**BEFORE THE COMMISSIONERS ON
BEHALF OF DUNEDIN CITY COUNCIL**

LUC 2017-48 and SUB 2017-26

SUPPLEMENTARY STATEMENT ON BEHALF OF ANTONI FACEY

Swept path on perimeter road

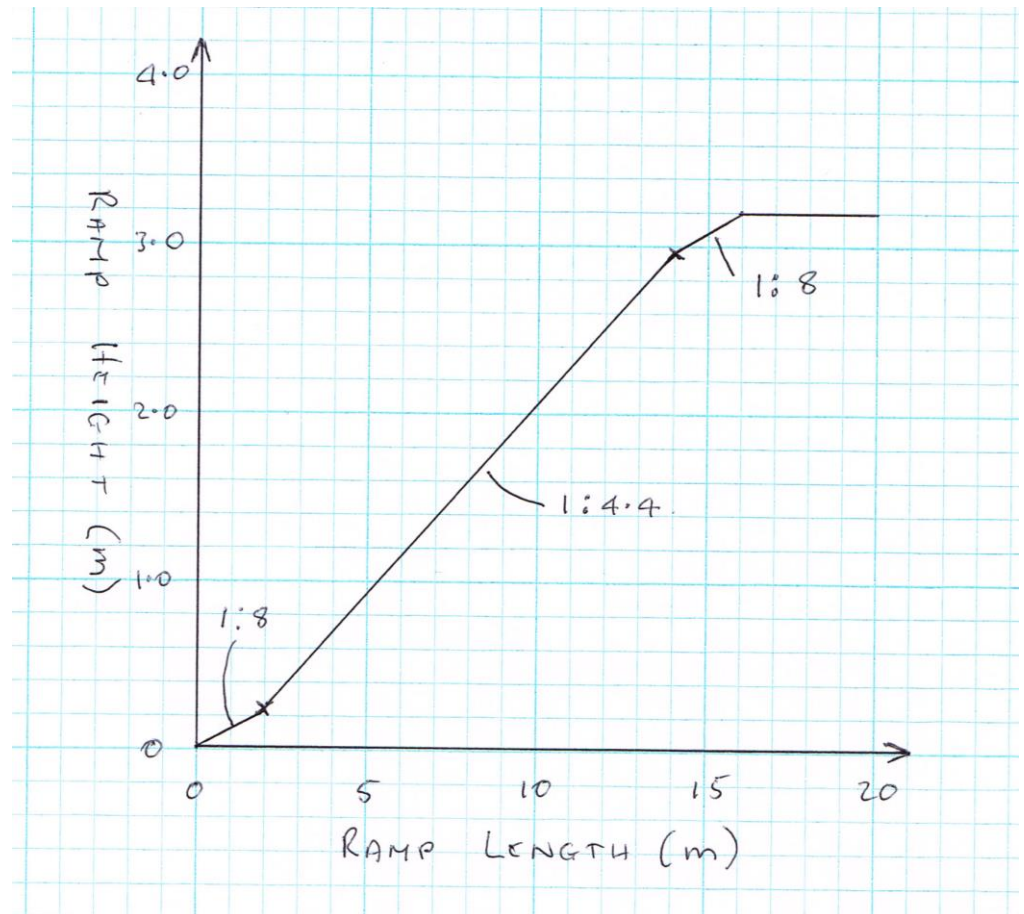
21. Mr Carr has made much of the inability of a coach to negotiate a horizontal curve on the ramp when a coach is parked in the western coach parking space on the ramp to Filleul Street.
22. It is clear from the turning path templates in RTS 18 that a coach can negotiate the curve when there are no coaches present on the ramp. See below.

23. As discussed, the 2GP does not require coach parking to be provided on site. No submissions were made during the district plan review hearings about this requirement. Therefore, the parking clauses not requiring coach parking are likely to become operative. This is considered appropriate because 5 star hotels typically are not required to have coach parking on site and the 2GP has recognised this. Coaches are normally parked off site and coach drivers are understood to prefer to park off site near their accommodation. Hence, long term, coach parks will not be required on site.
24. However, there is a potential timing issue where the 2GP may not be operative prior to the hotel construction. If the hotel is constructed with

marked coach parking spaces and IF the coach drivers use the parks, the hotel operator will manage the coach parking to ensure that the drivers are available to move the coach in the space that restricts movement as required. The space in question is the least desirable for coach drivers and would be the fifth and final space to be occupied IF the other 4 coach parking spaces are occupied.

25. Stacked parking is normally considered acceptable in special cases such as this if coaches are required to be parked on site. The location of the drivers will always be known to relocate the coaches if required.
26. This situation will be managed by the hotel operator if required.

Swept path on internal car park ramp

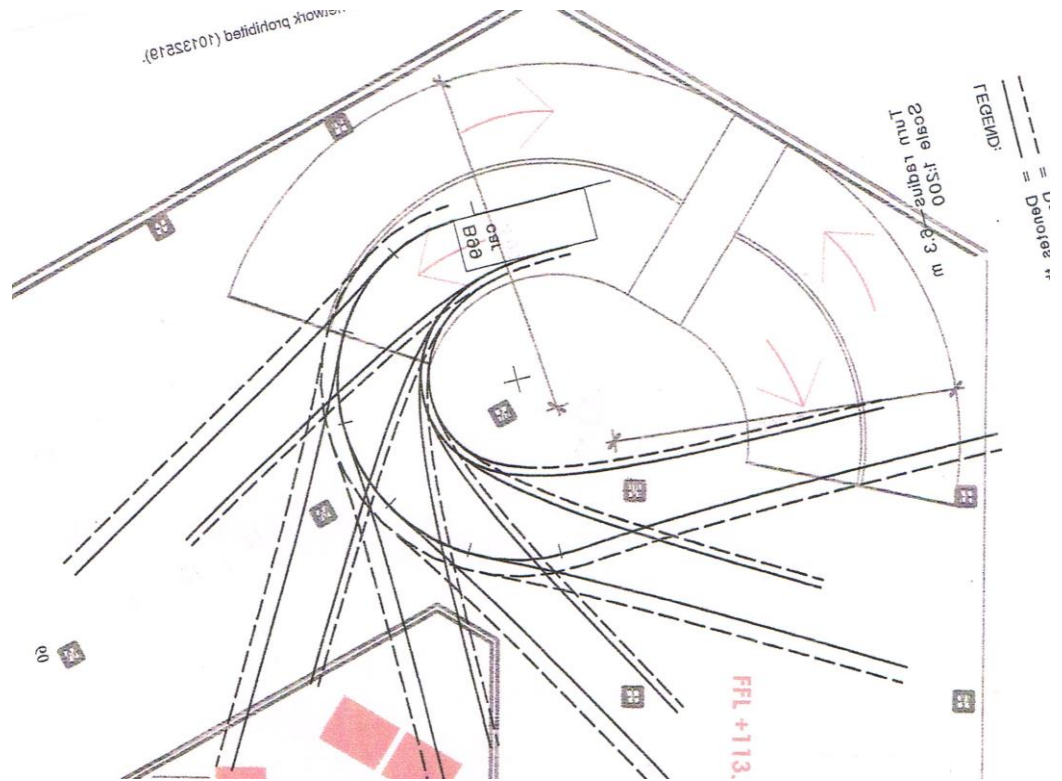
30. The internal car park ramps have been redesigned to demonstrate that they can operate as a two lane, two way ramp with generous width. The swept paths on the internal car park ramp have been checked and it is demonstrated that the cars can easily negotiate the curves on the ramp and the entry and exit to the ramp. The most critical case is shown below using the B99 car swept path from AS2890.1.

Figure 4.11 from AUSTROADS - Typical encroachment area detail at a roundabout

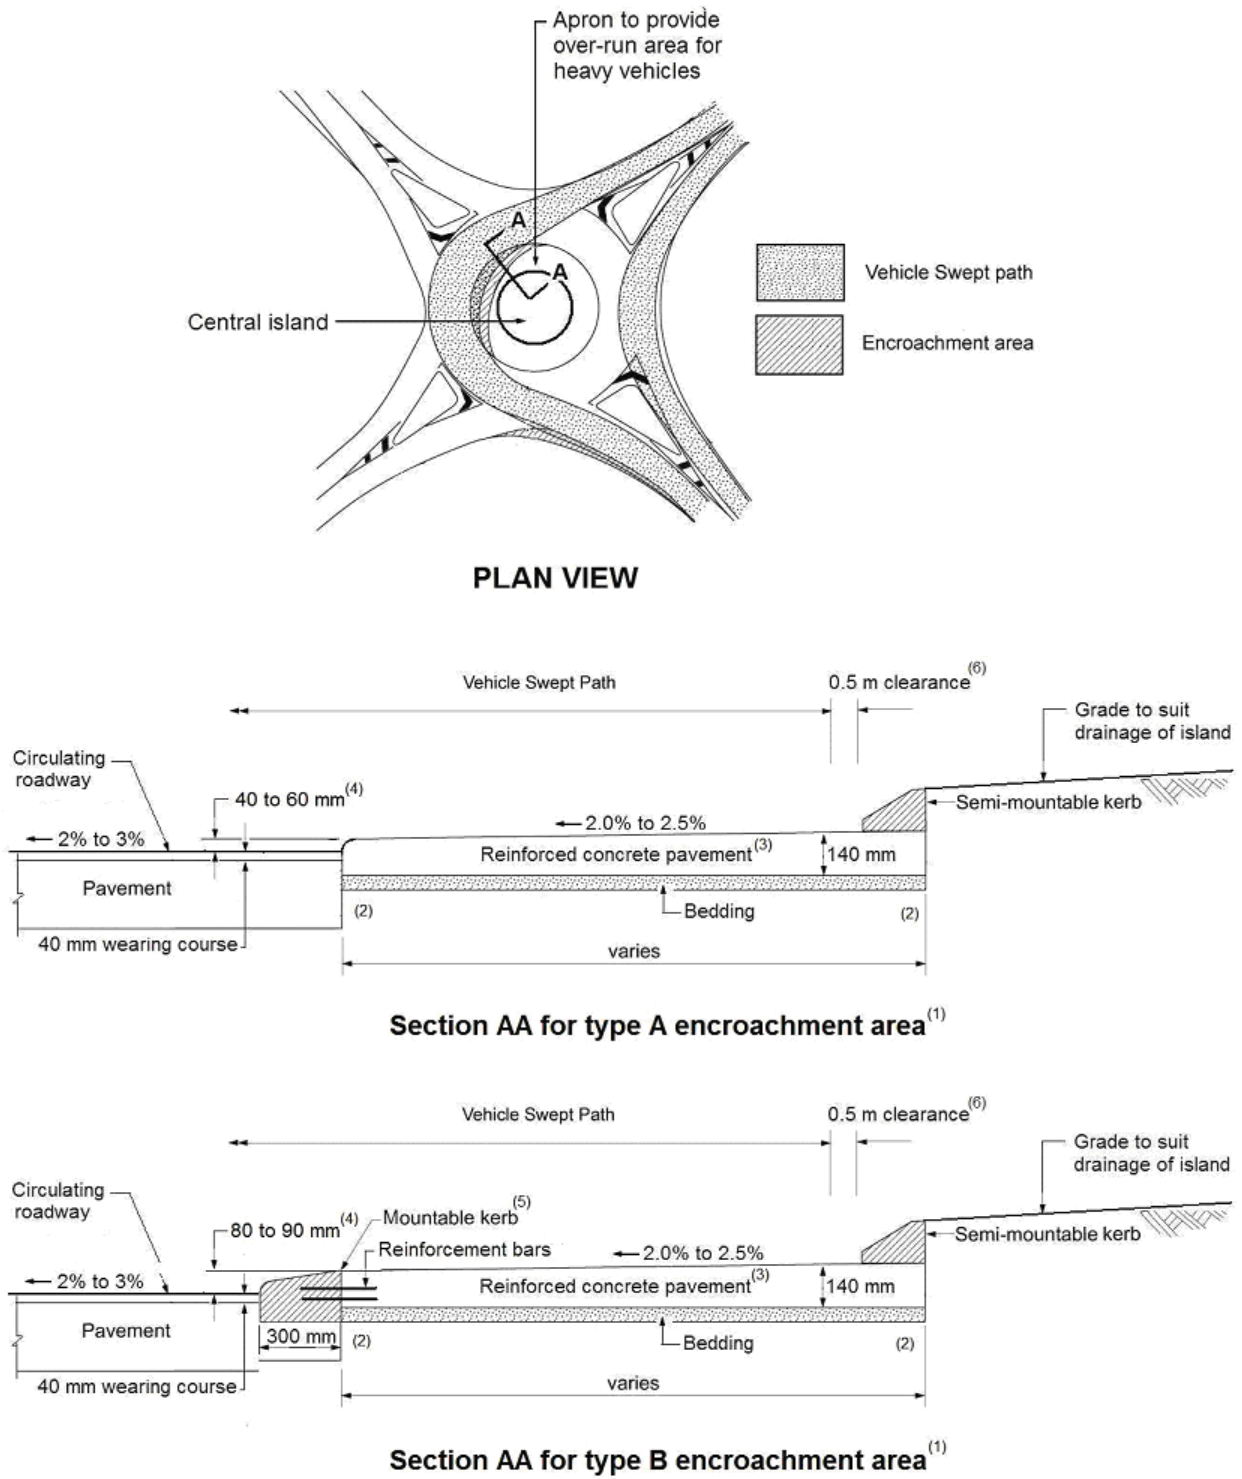
47. The plan to date shows only the extreme internal circulating island to accommodate a turning coach. A concentric circular roundabout ring of 8 metres radius is proposed around the central circulating island at a lower level to provide a split level roundabout. This outer ring will be fully mountable for trucks and coaches to use to complete their turns safely while cars would be discouraged from using this area to manoeuvre. Hence, deflection is developed and maintained for all vehicles to ensure that the roundabout operates at a low speed. Allowing encroachment like this is a standard method of roundabout design as shown in Figure 4.11 of AUSTROADS "Guide to Road Design part 4B-Roundabouts" reproduced below. The encroachable concentric area is considered to be the radius of the roundabout and the radius is therefore 8 metres.
